DATE: 12.11.2013

■ **BARCLAY WEST PHASE 1 INFRASTRUCTURE [TRC plan review]**

☞ Initial Review Note ☞

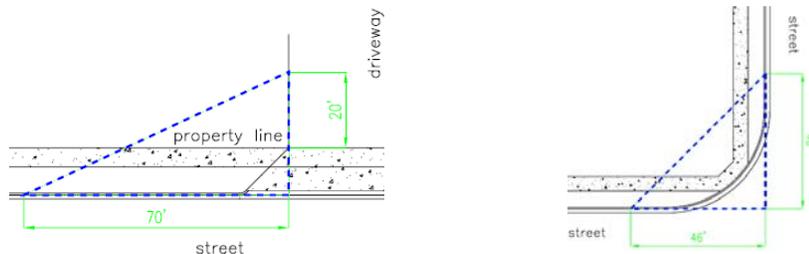
7. The circular intersections need to be designed as true roundabouts to provide efficient vehicle flow to and from the future traffic signal on Independence Blvd. Right-of Way and roadway layout may need to be altered from what is proposed to accomplish this. The plan appears to be a general concept as to approximate locations of the roundabouts. Is this the case? See the provided concept. If you wish to discuss the roundabout design, please contact Dave Brent w/ Traffic Engineering at 910-341-4677.
